**DOMINION NUCLEAR CONNECTICUT, INC.**  
**MILLSTONE POWER STATION UNIT 2**  
**RESPONSE TO REQUEST FOR ADDITIONAL INFORMATION REGARDING THE**  
**CYCLE 21 CORE OPERATING LIMITS REPORT (TAC NO. ME6365)**

**RESPONSE TO REQUEST FOR ADDITIONAL INFORMATION REGARDING  
THE CYCLE 21 CORE OPERATING LIMITS REPORT**

**DOMINION NUCLEAR CONNECTICUT, INC.  
MILLSTONE POWER STATION UNIT 2**

**Figure 3-1**  
Histogram showing the distribution of “Relative Error in Nodal Power” between the misaligned and normal incore detector configurations

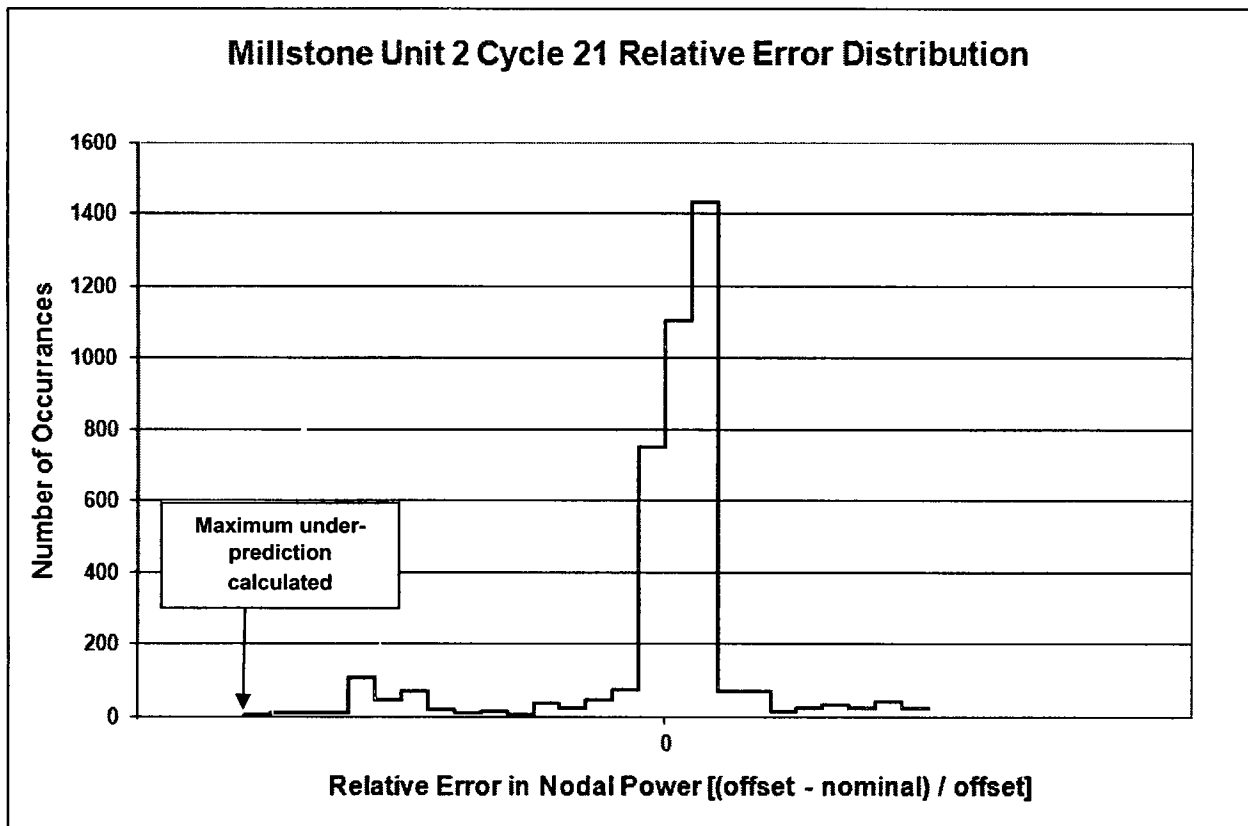
Is the impact of the offset ICI detectors on the revised acceptable operating region (Figure 2.5-1) conservative? Is the revised penalty factor specified in item 2.5 conservative?

A conservative penalty factor was determined based upon the following conditions:

- All 26 affected incore detector strings were conservatively assumed to be offset by the maximum amount of 1.375 inches relative to the nominal configuration.
- The relative difference in the power reconstruction due to the offset detectors was assessed using the INPAX-II methodology for limiting incore detector locations at multiple burnup intervals throughout the cycle.
- For Cycle 21, the maximum under-prediction in determining the “measured” nodal power as a result of the misaligned detectors is used to formulate the penalty. The histogram in Figure 3-1 shows the resulting distribution of the “relative error in nodal power” between the misaligned and normal incore detector configurations.
